## CITY of NOVI CITY COUNCIL

**Agenda Item 3**  
**August 8, 2016**

**SUBJECT:** Approval of the request of TBON, LLC for approval of Special Land Use, Preliminary Site Plan, Wetlands Permit and Stormwater Management Plan. The request is for an expansion of the existing showplace exposition facility by adding a 175,815 square foot building addition, with associated parking lot and other site improvements for land within the OST, Planned Office Service Technology District, and in the OST, Planned Office Service Technology District with an EXO, Exposition Overlay District. The subject property is located in Section 16, north of Grand River Avenue and west of Taft Road.

SHEET + NUMBER  
**A5.00**

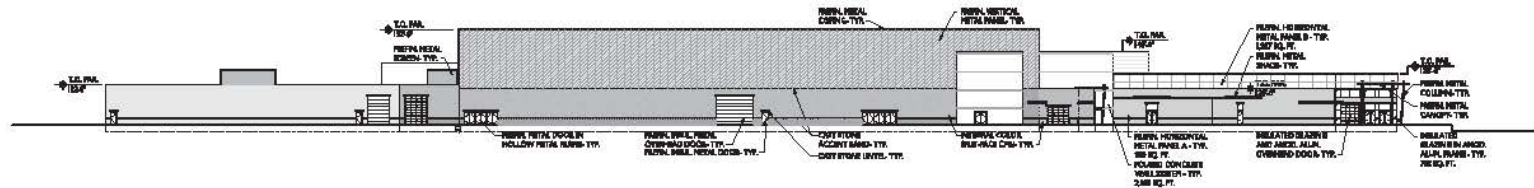
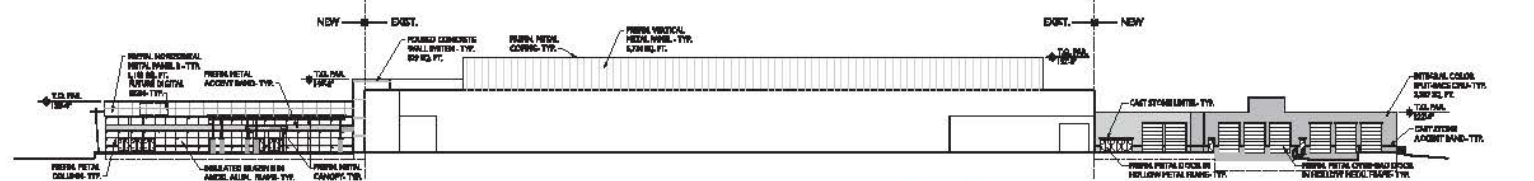
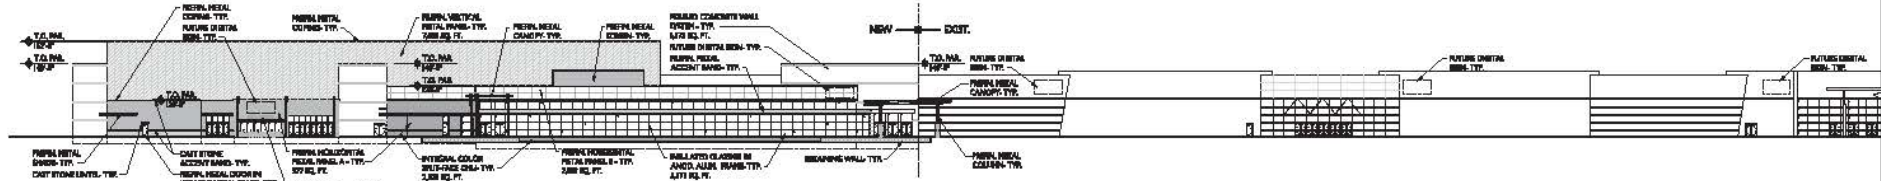
8. **Facade Waiver:** A section 9 waiver would be required for the overage of Horizontal Rib Metal Panels, Vertical Metal Panels and Split Faced CMU. The City's Façade Consultant is in support of the Section 9 waiver in this case because the submitted renderings show that the proposed addition will harmonize well with the existing structure; careful attention to detail with respect to overall massing and design of main

entrances is evident; and similar treatment of the existing and proposed entrance canopies will create a unifying element for the overall building. Additional landscape screening may be needed to screen the truck dock area along the north and east sides.

- a. A section 9 façade waiver for the overage of:
  1. Horizontal Rib Metal Panels (Allowed: 0 percent; Proposed: a maximum 15 percent on south, 5 percent on north, 3 percent on east and 8 percent on west),
  2. Vertical Metal Panels (Allowed: 50 percent; Proposed: 60 percent on north and east side); and
  3. Split Faced CMU (Allowed: 10 percent; Proposed: 15 percent on south, 35 percent on North, 24 percent on east and 43 percent on west);

PROPOSED SITE LANDSCAPE PLAN

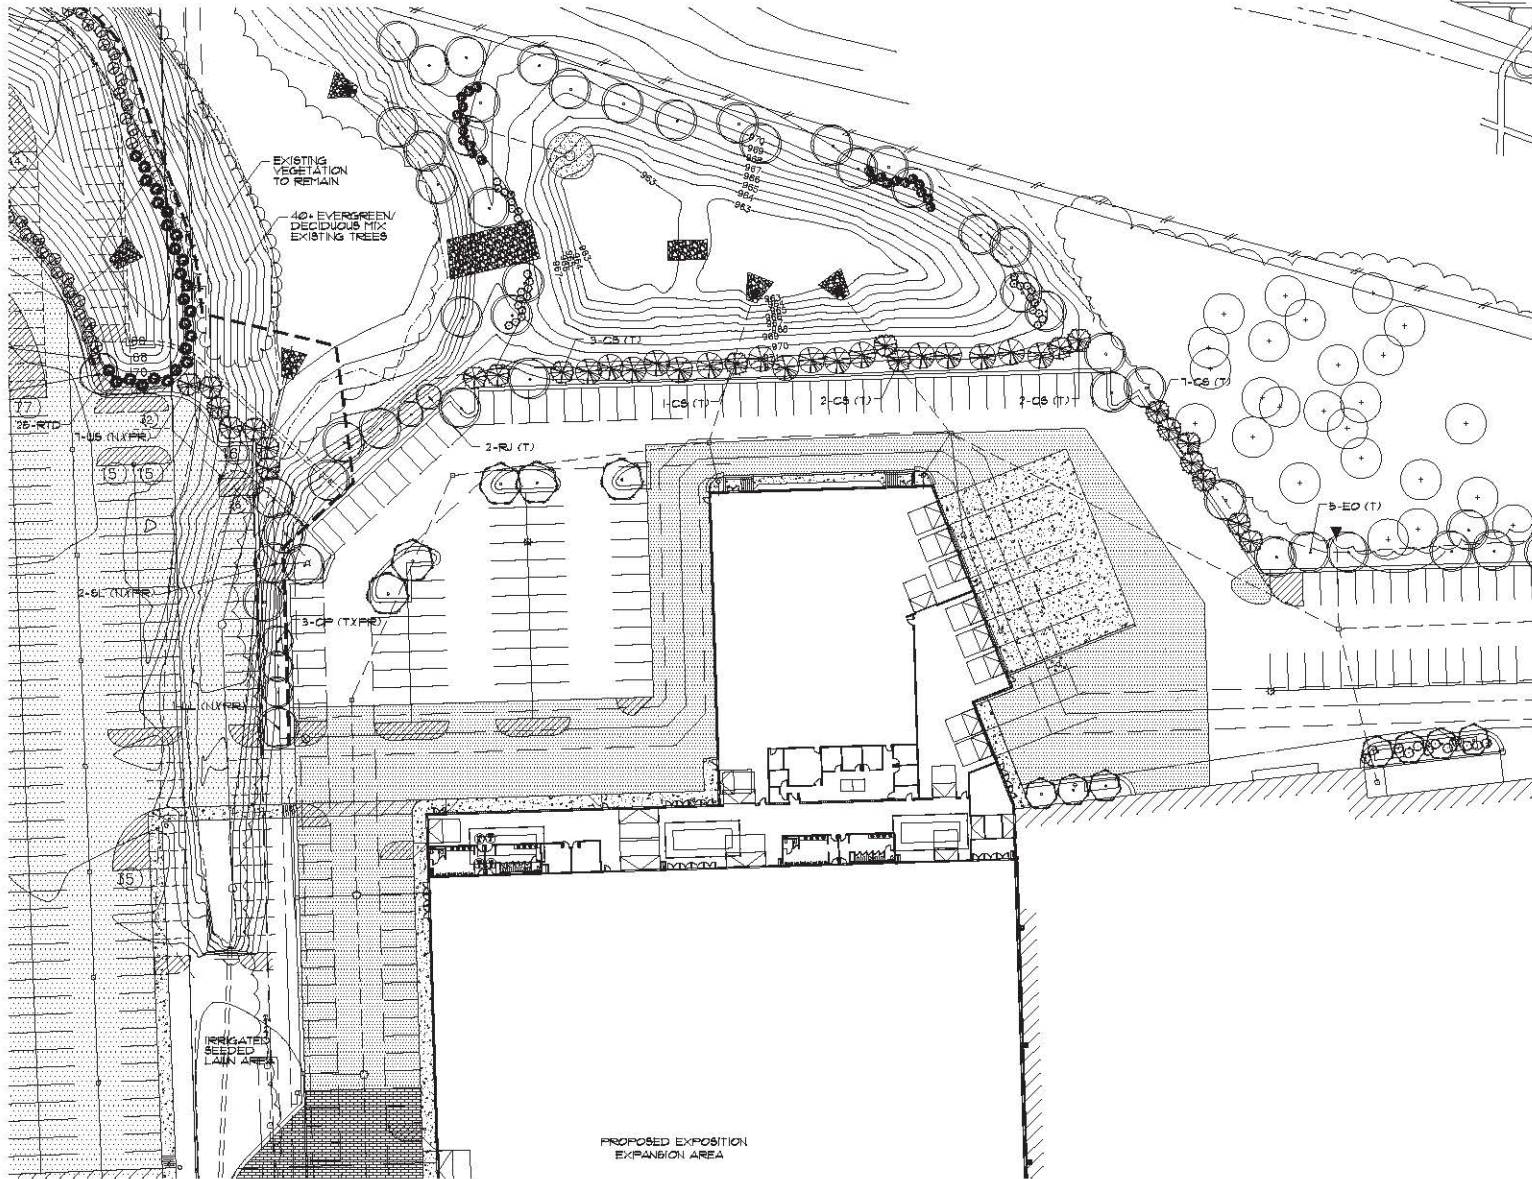
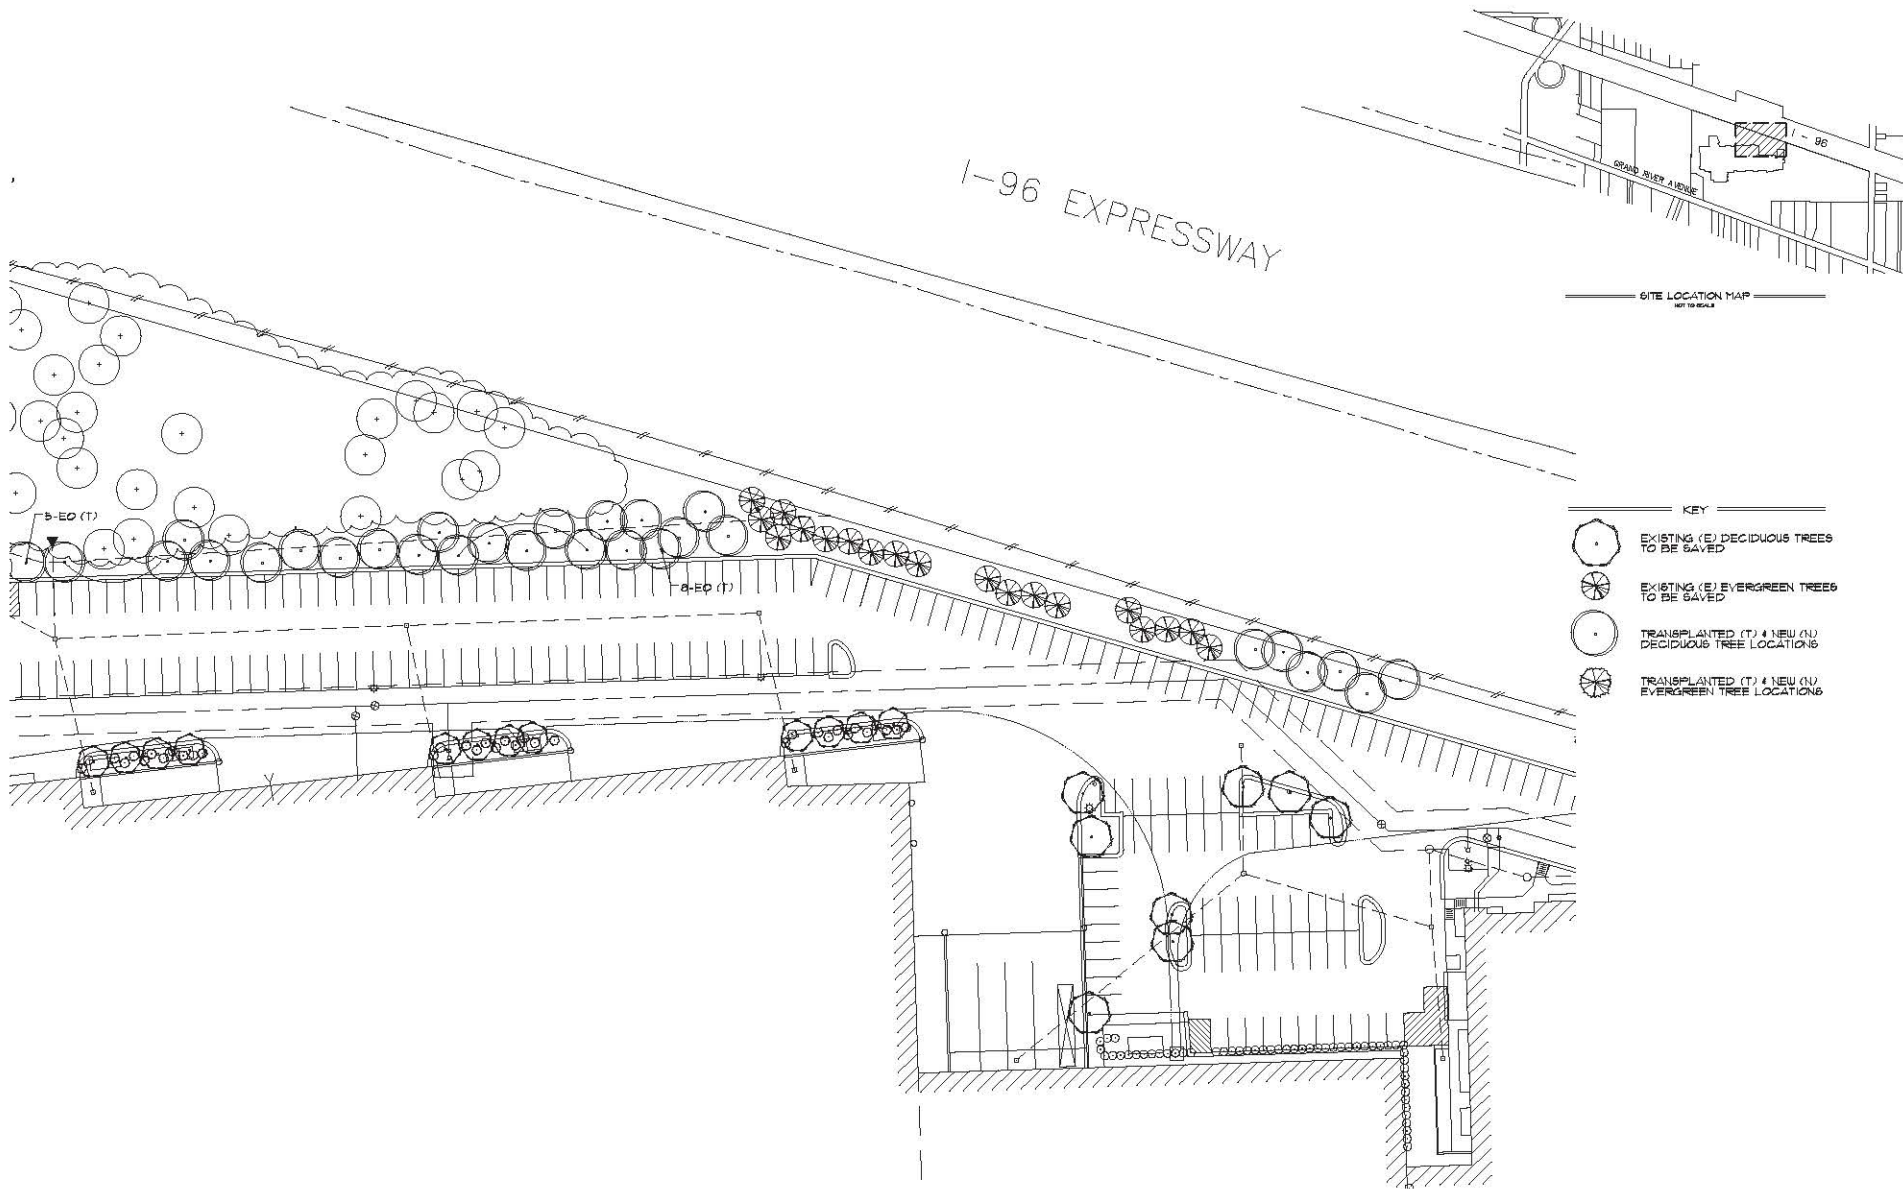
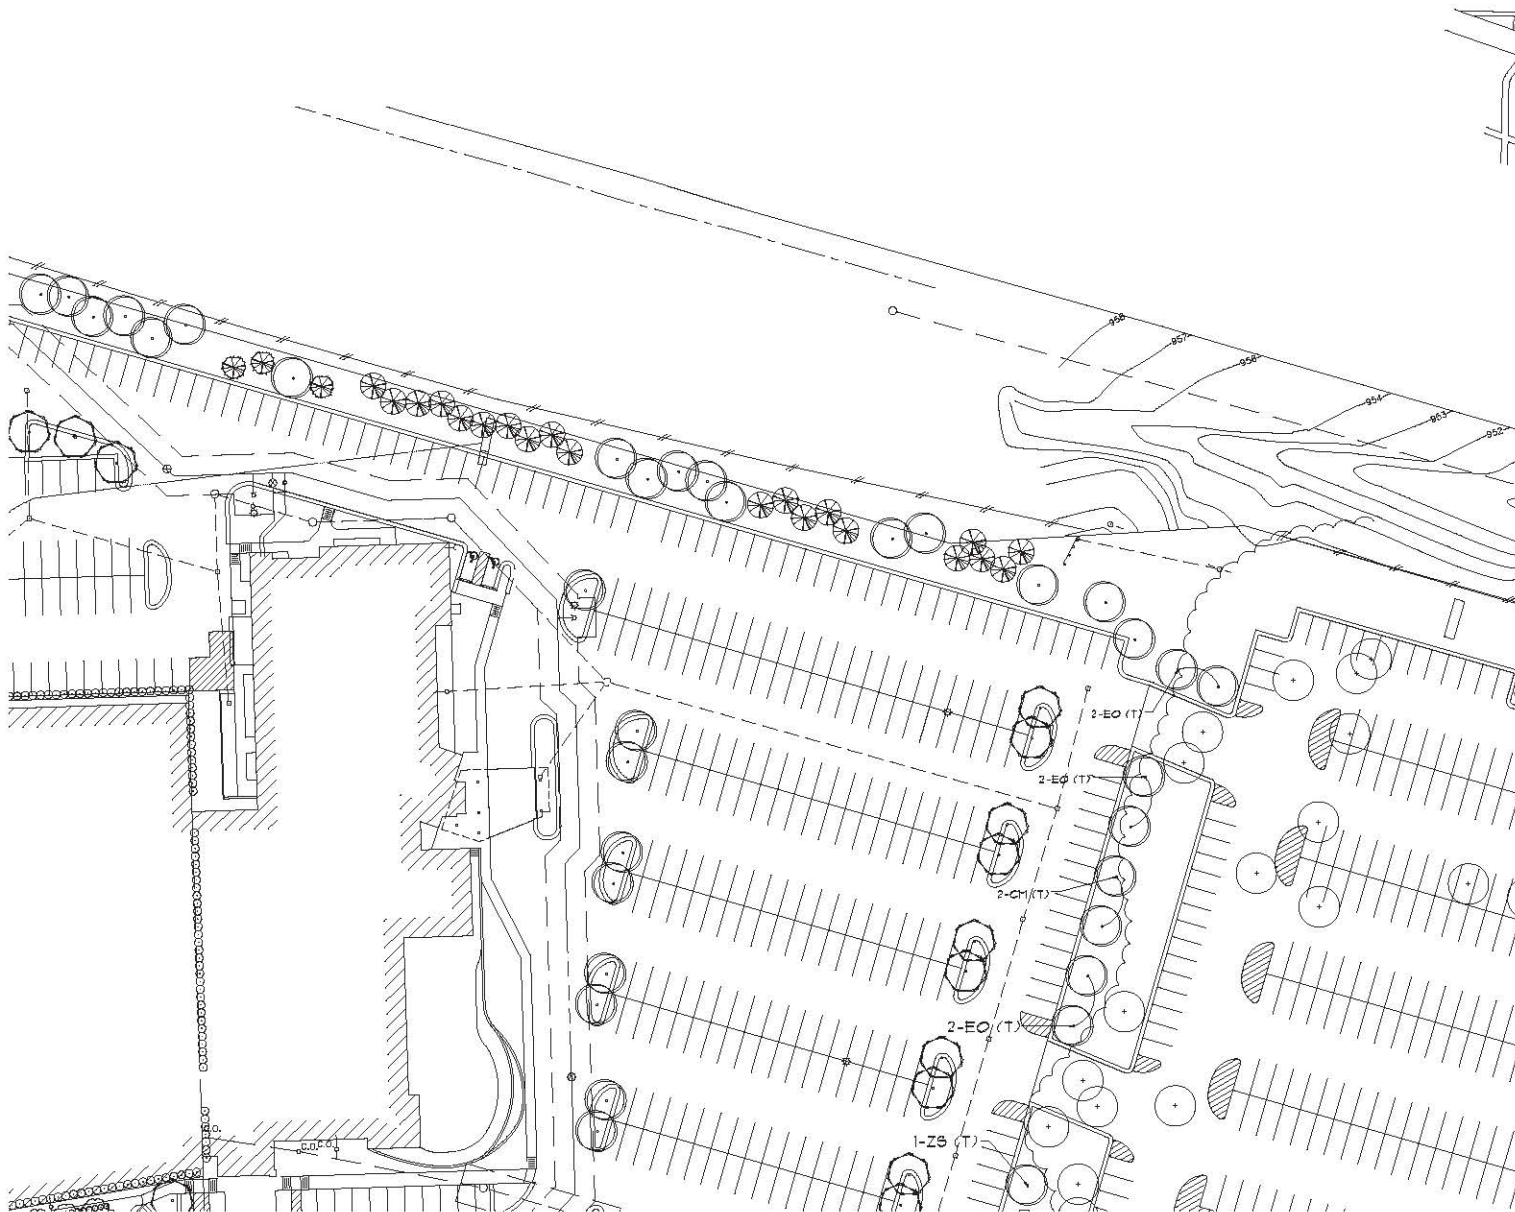
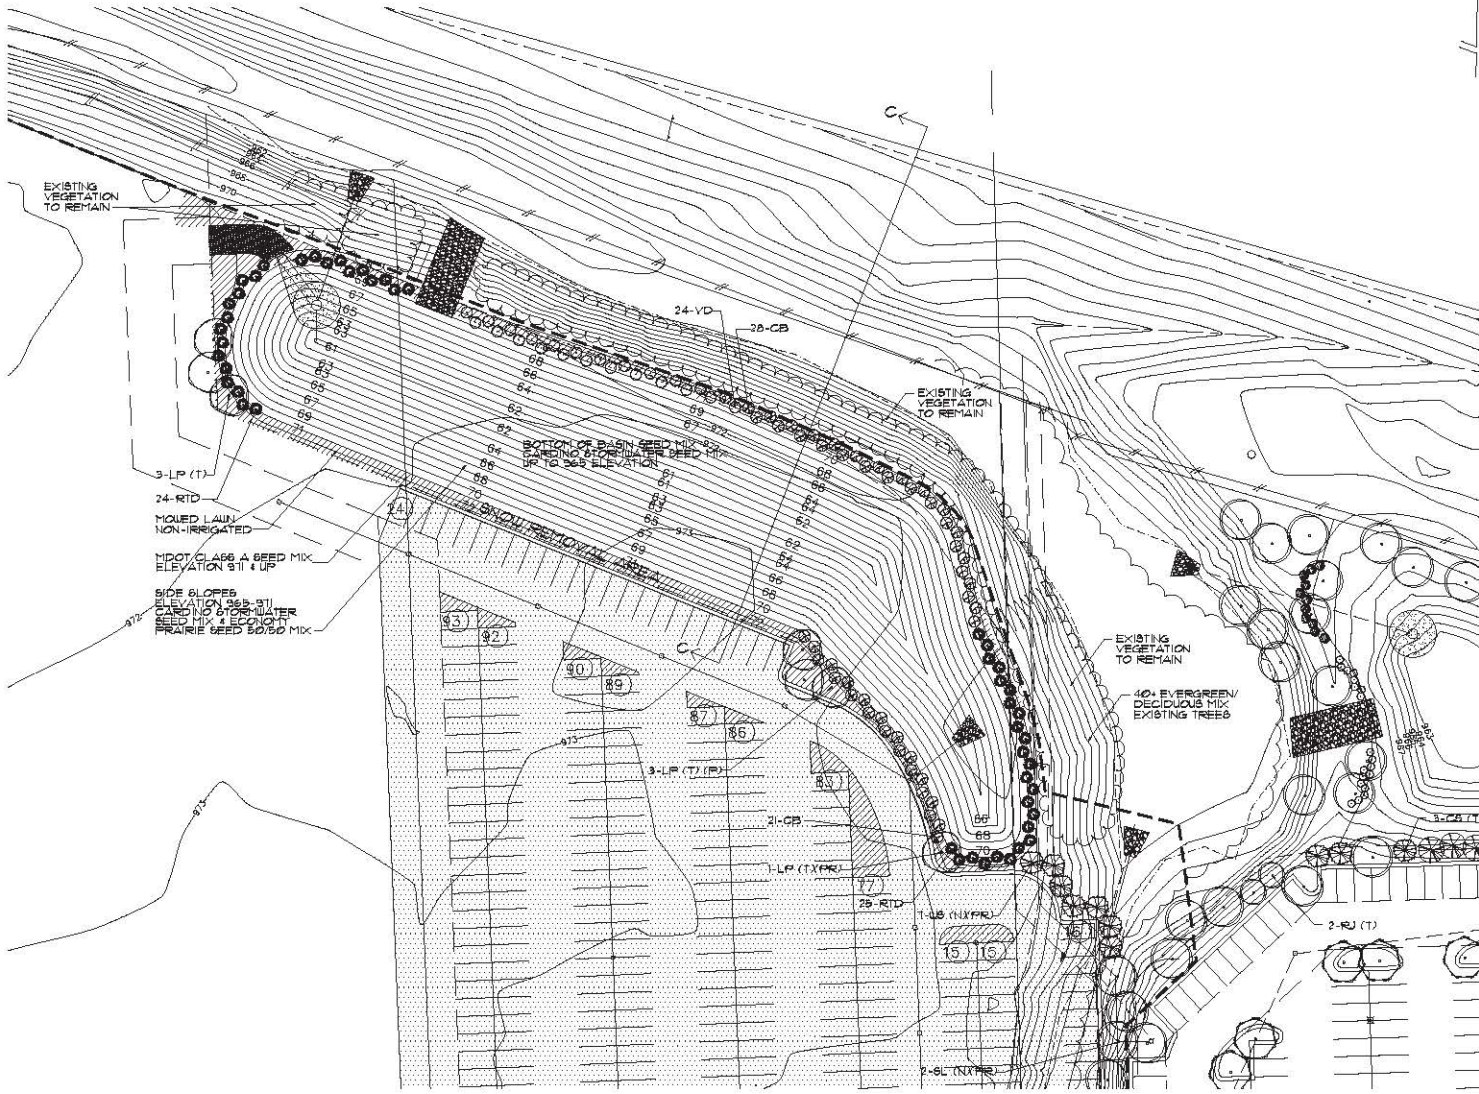
7. **Landscape Requirements:** Multiple landscape waivers are needed for deficiencies:
  - a. **Parking lot Island Space (Sec 5.5.3.C.iii):** absence of required landscaped area within the parking lot (approximately 15,664 square feet is required, 0 provided).

- b. **Interior Parking Lot Trees (Sec 5.5.3.C.iii):** absence of parking lot interior trees (approximately 209 canopy deciduous trees required, 0 provided)

- c. **Parking Lot Perimeter Trees (Section 5.5.3.C, chart footnote):** absence of parking perimeter trees along the western edge (approximately 50 trees required, 35 provided),

- d. **Foundation Plantings (Sec. 5.5..D):** reduction of required foundation plantings (14,592 square foot required, 2,258 square foot provided); and

- e. **Contiguous spaces in parking bay (Sec. 5.5.3.C.ii.i):** exceeding the maximum number of contiguous spaces within a parking bay (15 maximum allowed, a maximum of 93 provided).

Staff is in support of the landscape ordinance deficiencies only to the extent that flexibility is needed since the new parking area is also intended to be used as a Ride and Drive Automotive Research Lot and other activities that are not consistent with daily parking activities. Staff suggests landscape end islands be placed as needed for traffic and pedestrian pathway safety at the time of Final Site Plan submittal as included in the suggested motion.

- c. A Landscape waiver to permit the absence of required landscaped area within the parking lot (approximately 15,664 square feet is required, 0 provided), as listed in Section 5.5.3.C.iii;

- d. A Landscape waiver to permit the absence of parking lot interior trees (approximately 209 canopy deciduous trees required, 0 provided), as listed in Section 5.5.3.C.iii;

- e. A Landscape waiver for exceeding the maximum number of contiguous spaces within a parking bay (15 maximum allowed, a maximum of 93 provided) as listed in Section 5.5.3.C.ii.i to allow for alternate use of parking lot as a Ride and Drive Automotive Research Lot and other activities, subject to *landscape end islands be placed as determined by the City Engineer for traffic and pedestrian pathway safety adjacent to the pedestrian crosswalk in the new paved lot, and near the southwest and northwest corners of the new building, with final approval at the time of Final Site Plan submittal*;

- f. A Landscape waiver to permit the absence of parking perimeter trees along the western edge (approximately 50 trees required, 35 provided), as listed in Section 5.5.3.C, chart footnote;

- g. A Landscape waiver to permit reduction of required foundation plantings as listed in Section 5.5.3.D (14,592 square foot required, 2,258 square foot provided) due to the proposed use of outside concert venue;
